ADDENDUM NO. 1

DOUGLAS MACARTHUR ELEMENTARY SCHOOL ADDITIONS, RENOVATIONS, AND RELATED WORK Crown Point, IN 46307

ADDENDUM ONE

Addendum One (AD.01) to the drawings and specifications prepared by Gibraltar Design for **MacArthur Elementary School Additions & Renovations** for Crown Point Community School Corporation, Crown Point, Indiana.

Thursday, 2/10/2022 — 1:55 PM — LAST SAVED BY:DBURNS Y:\21—113 CROWN POINT CSC — MACARTHUR ES ADDITION AND RENOVATIONS\21—113 DRAWINGS\05 ARCH\A—212.DWG

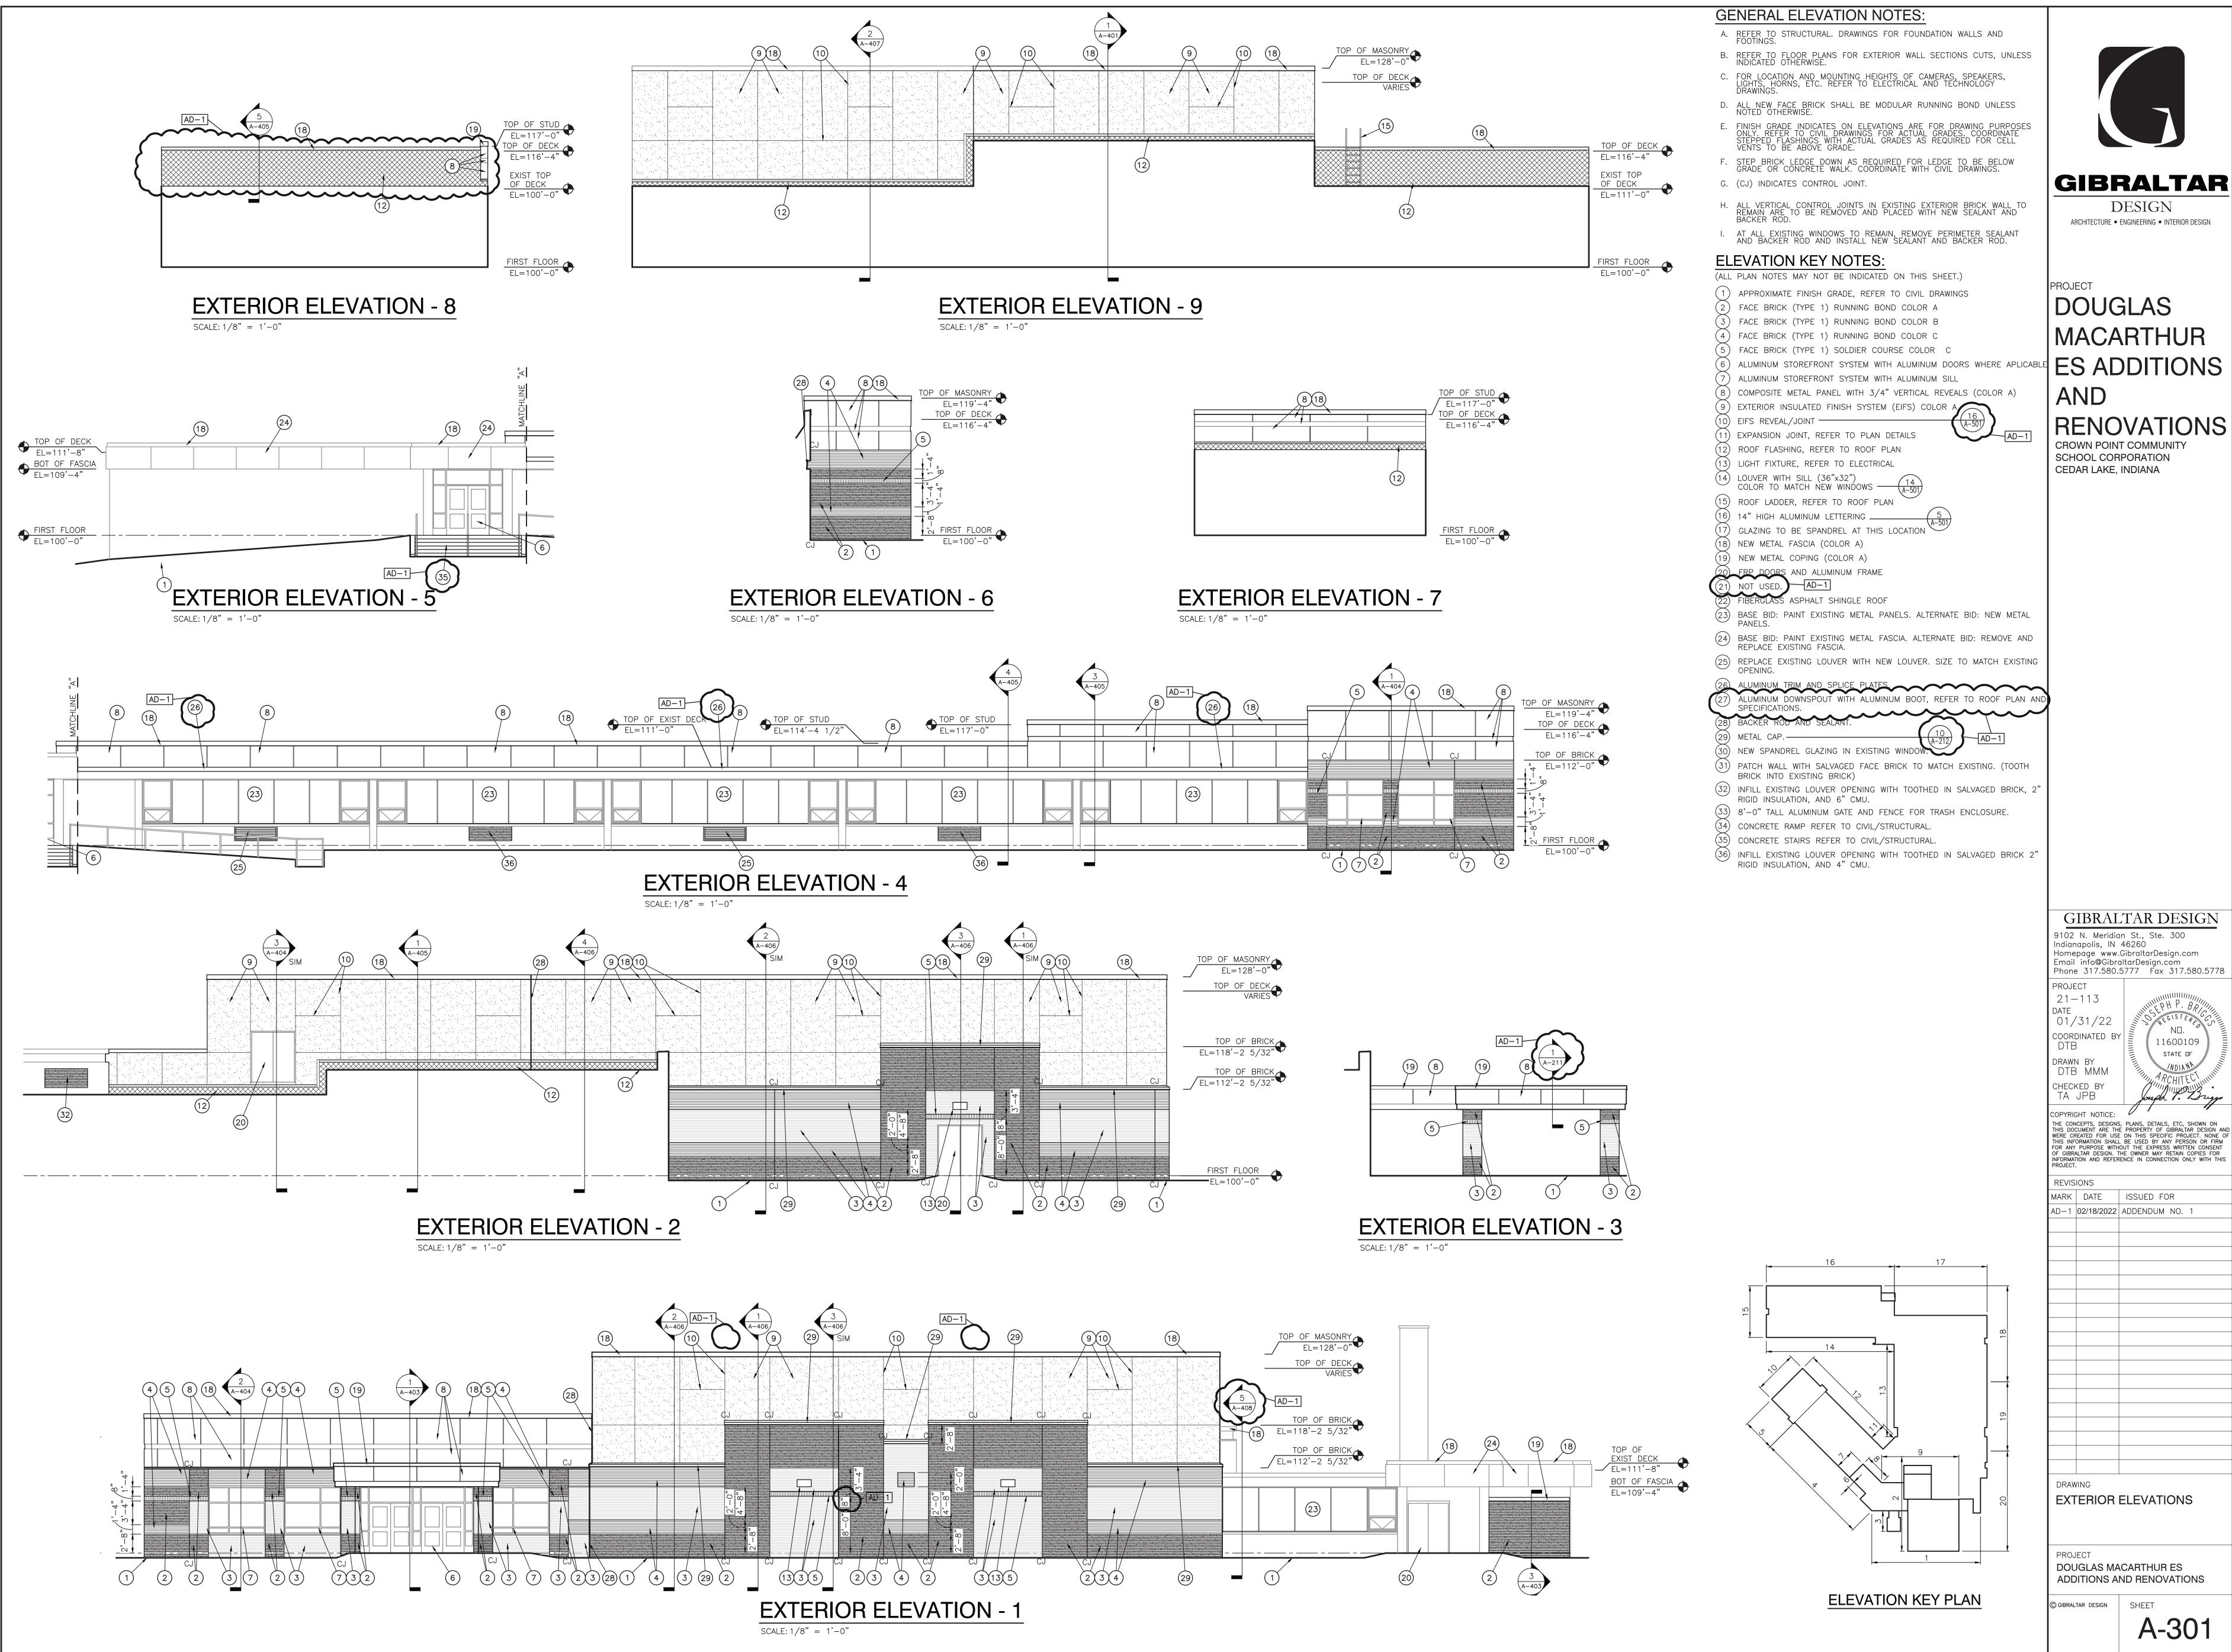
1. Sheet A-212

- A. Refer to revised, full-size drawing, included in this Addendum, for the following revisions:
 - 1. Revise Metal Fascia Details 2/A-212, 3/A-212, and 4/A-212.
 - 2. Revise Specialty Roof Drain Detail 9/A-212.

A-301

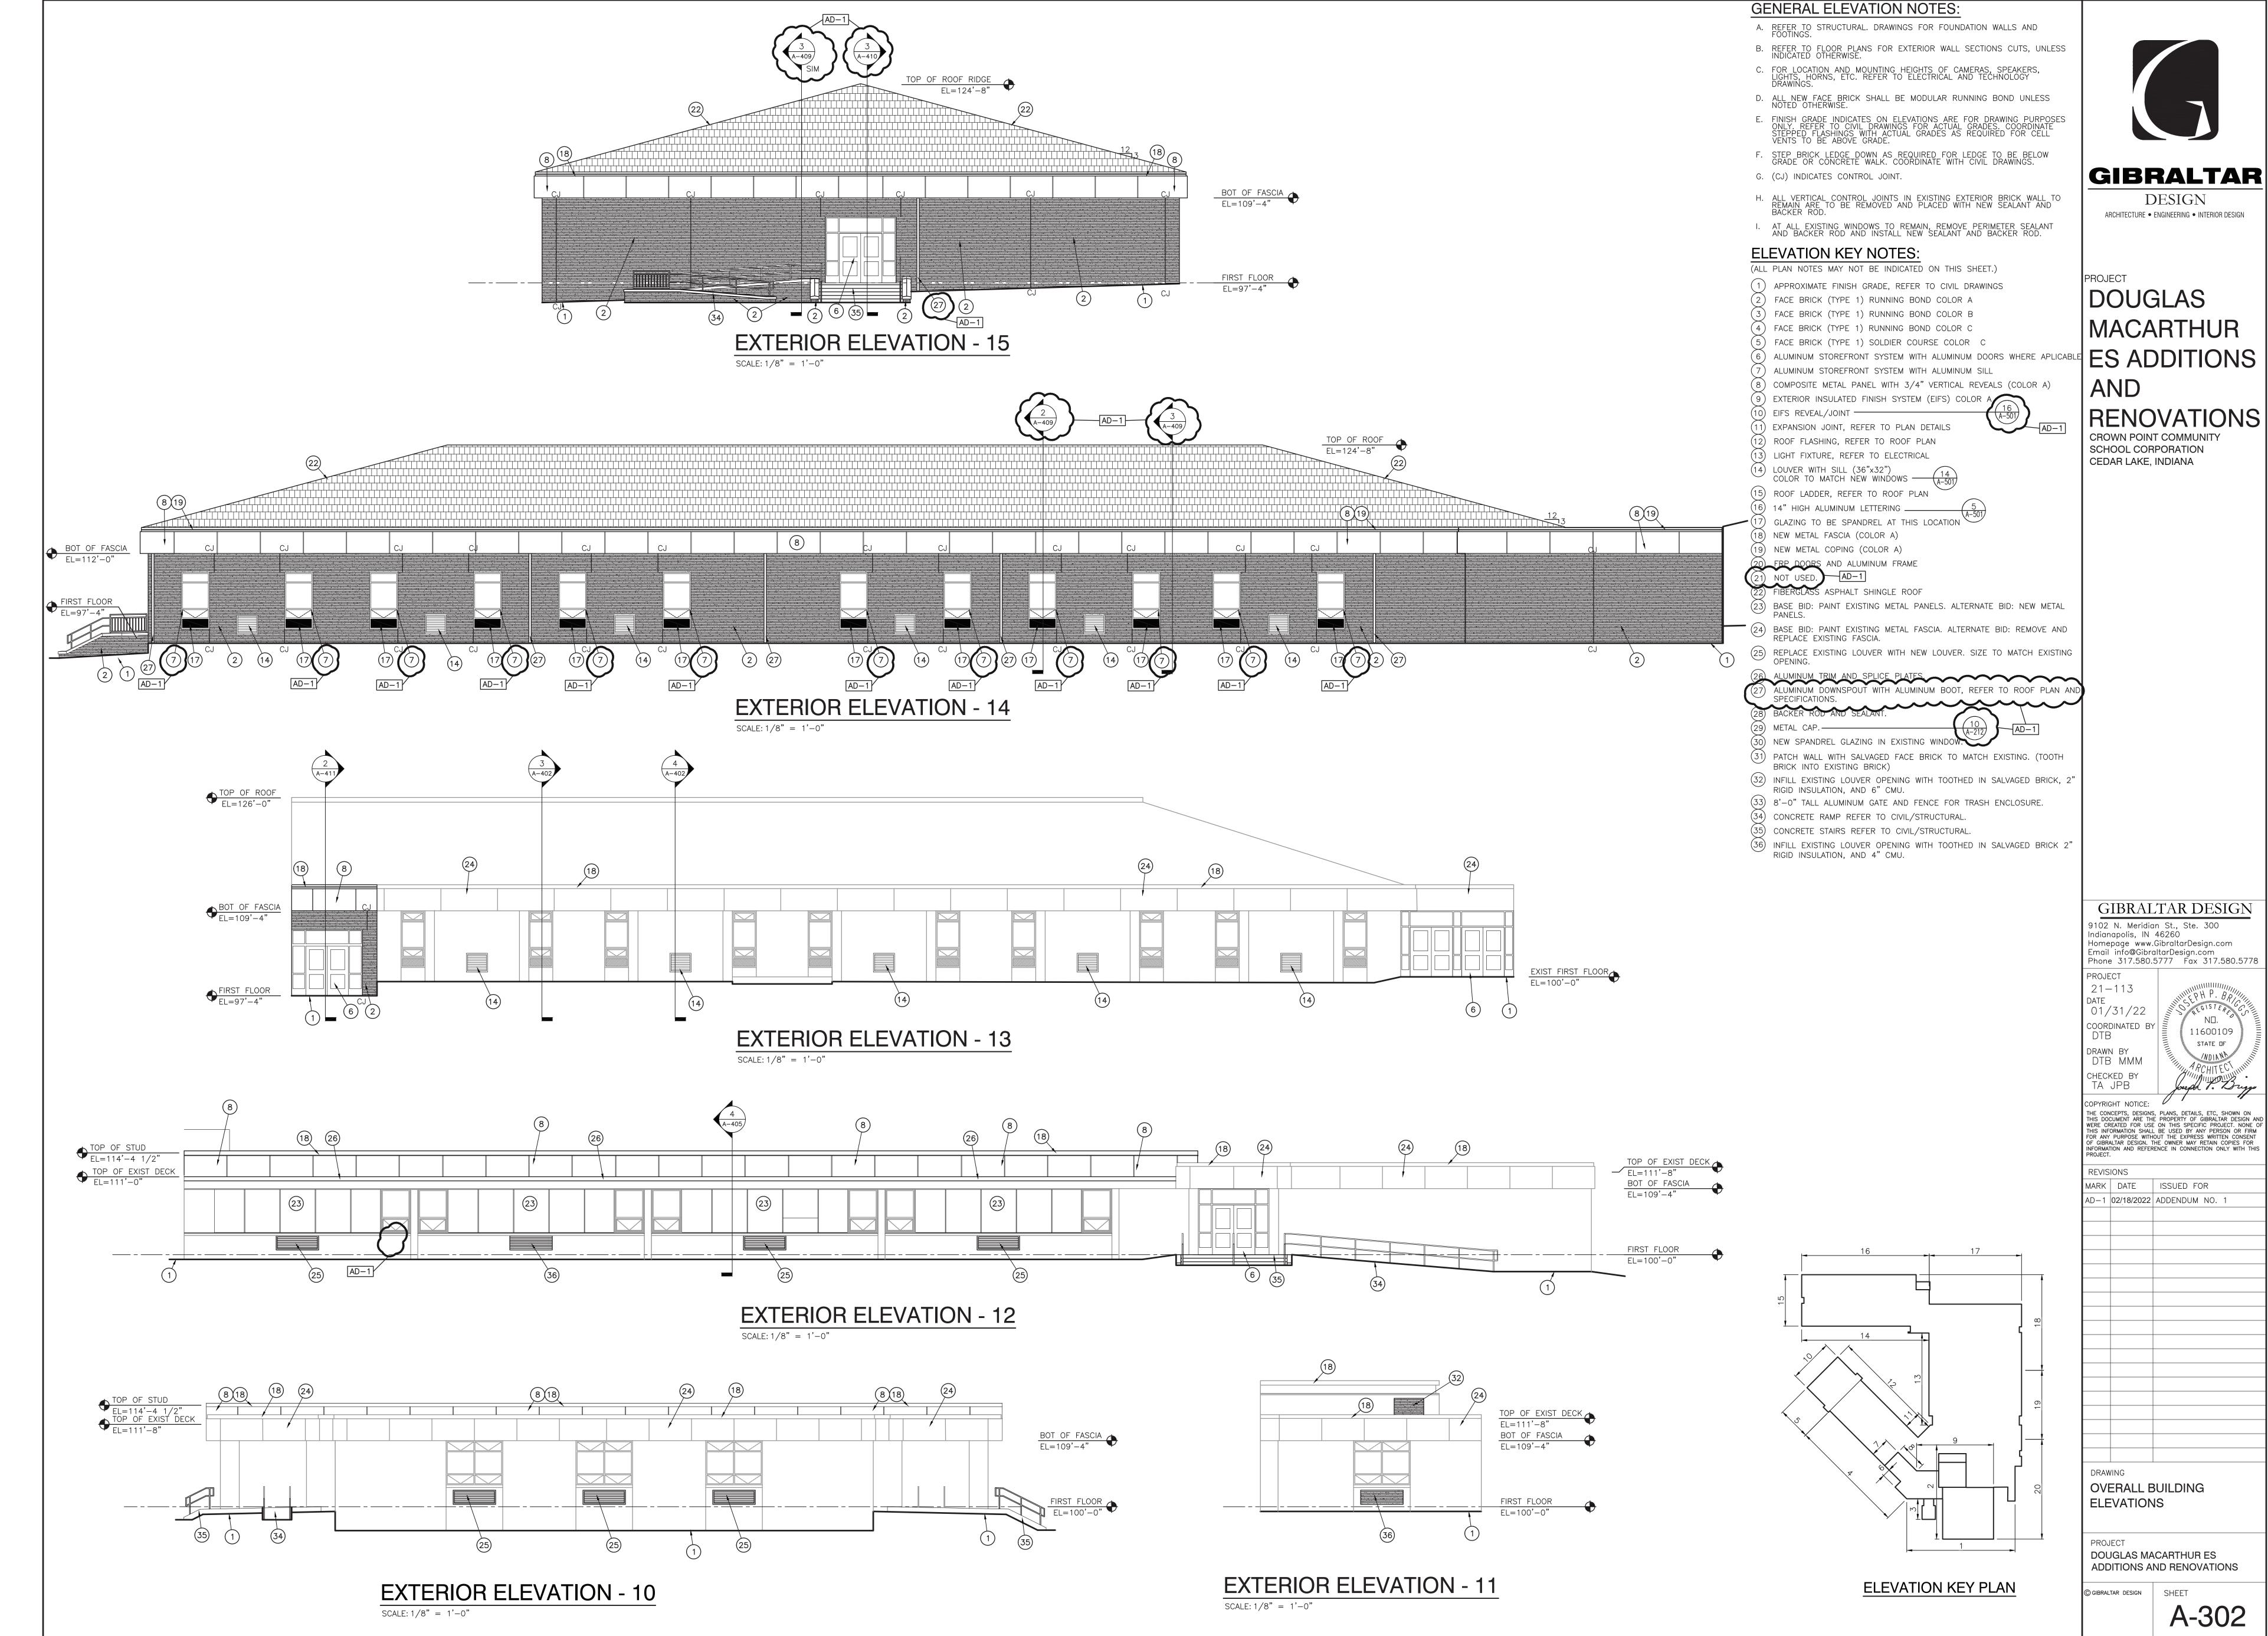
2. Sheet A-301

- A. Refer to revised, full-size drawing, included in this Addendum, for the following revisions:
 - 1. Revise Notes 10, 21, 27, and 29.
 - 2. Minor revisions to elevations 1,3,4,5, and 8.

Thursday, 2/10/2022 - 12:00 PM - LAST SAVED BY:DBUR Y:\21-113 CROWN POINT CSC - MACARTHUR ES ADDITION AND RENOVATIONS\21-113 DRAWINGS\05 ARCH\A-421 DWG

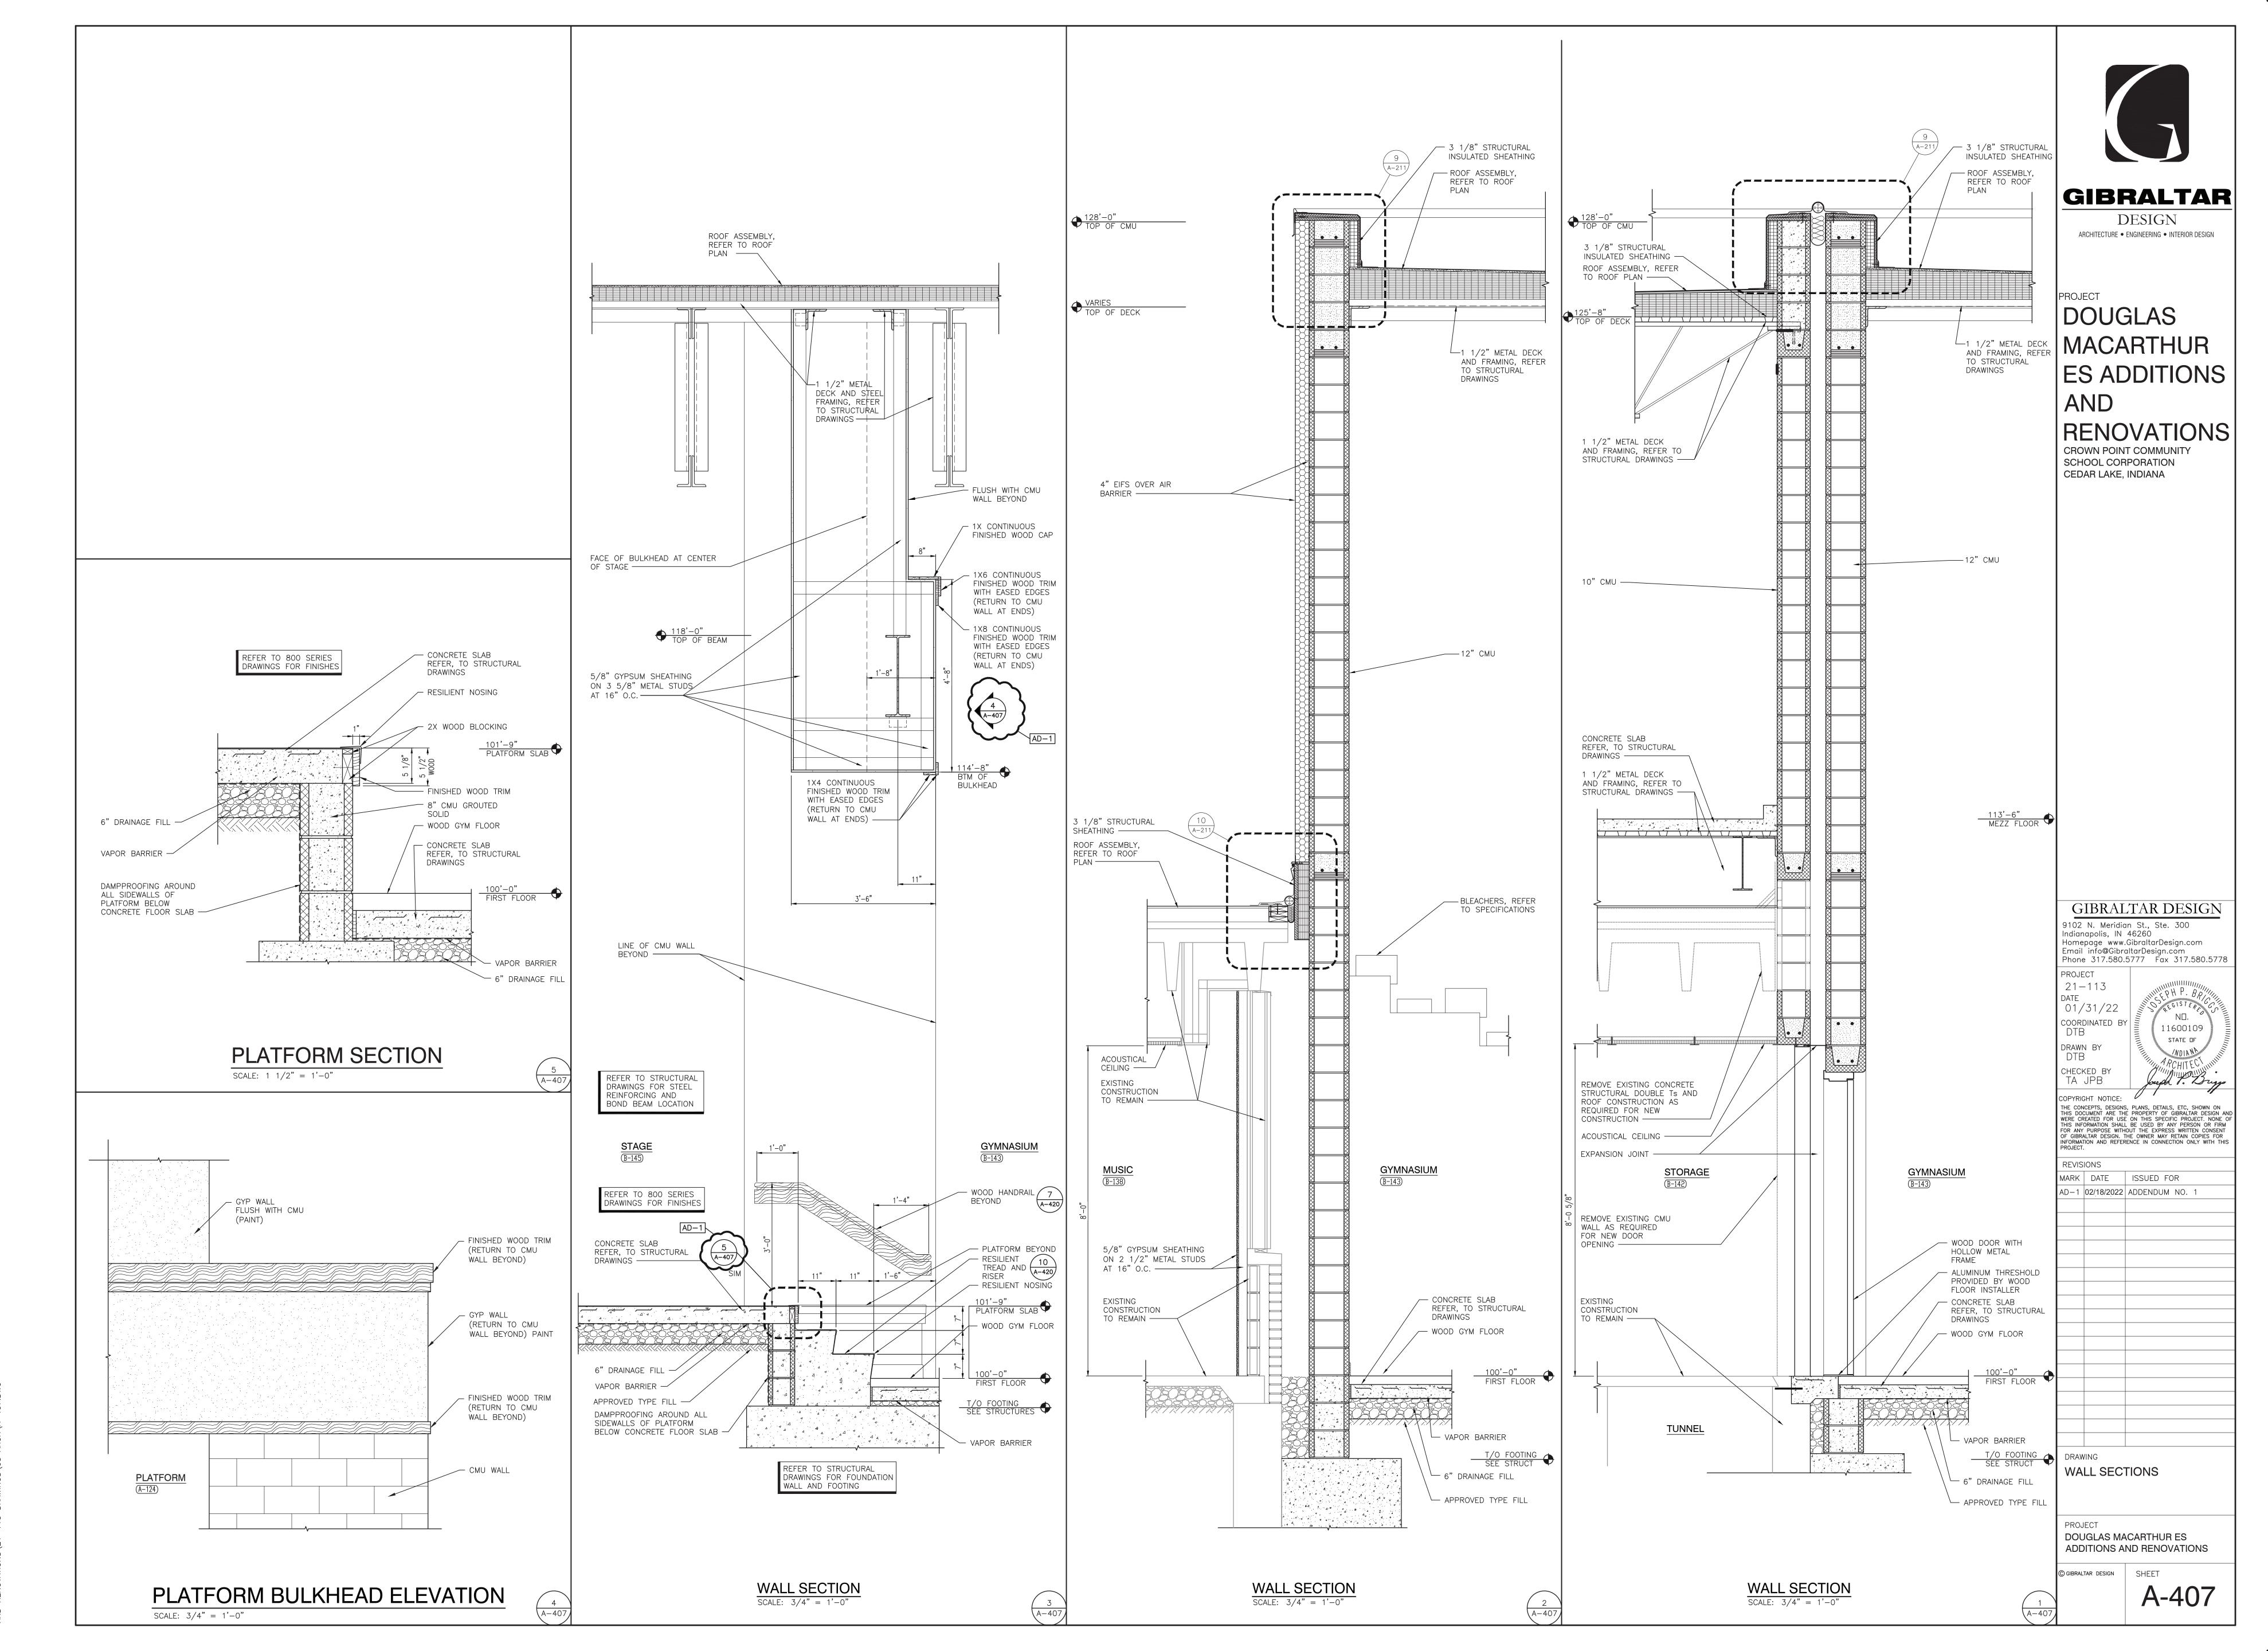
7. Sheet A-421

- A. Refer to revised, full-size drawing, included in this Addendum, for the following revisions:
 - 1. Revise sections 1/A-212, 2/A-212, and 3/A-221
